CITY OF ALBUQUERQUE

**RE: Family Dollar
1400 Gibson Blvd SE
Grading Plan
Engineers Stamp Date: 12/12/17 (L15D049)**

FAMILY DOLLAR STORE
GRADING & DRAINAGE PLAN

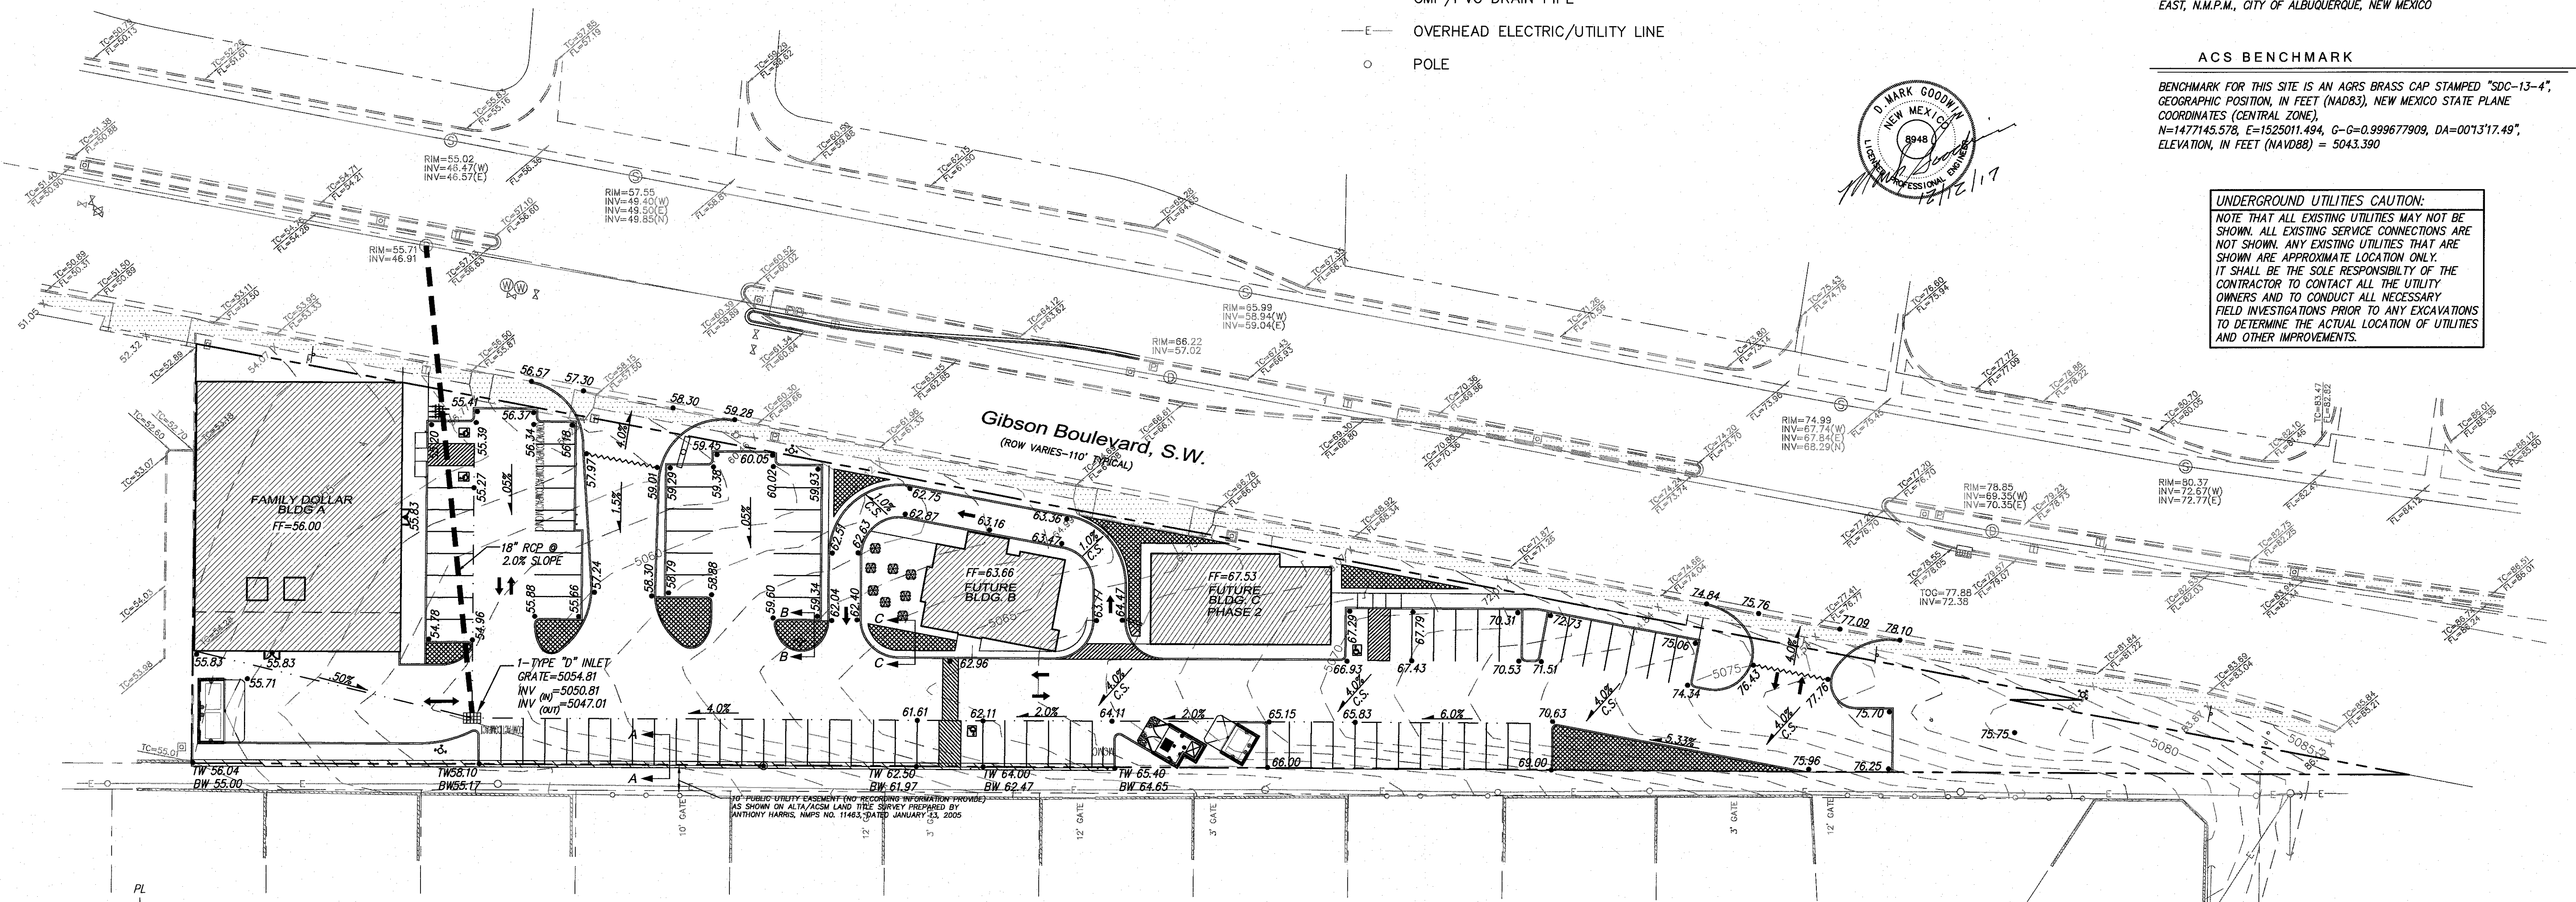
1. The property lines do not appear to match the Bernalillo County parcels. Please provide a current ALTA Survey and clearly show property lines on the grading plan.

2. This site must demonstrate downstream capacity before any increase in runoff can be approved.
3. Stormwater quality ponds need to be located where they can intercept all flows from the impervious areas.

4. It is unclear what is being built with this project. Is all of the paving being completed with this phase, leaving only building pads for phase 2? Or, is only enough paving to serve the Family Dollar being completed?

6. The stormwater quality ponds will need private facility drainage covenants.

SECTION A-A

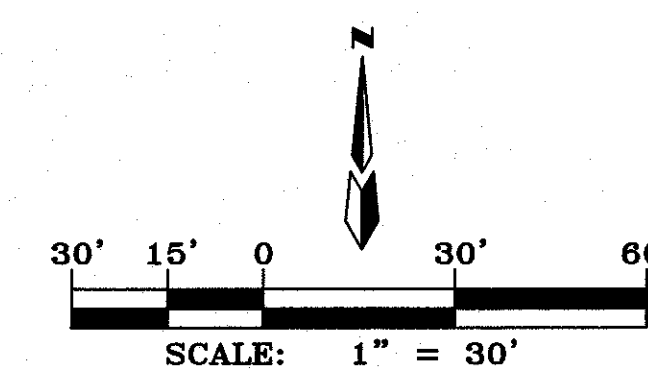
5. Work along the southern boundary needs to be clarified. Extend the section view to show existing and proposed grades and the existing walls. If a new wall straddling the property line is required, written permission from the adjoining landowners will need to be obtained.
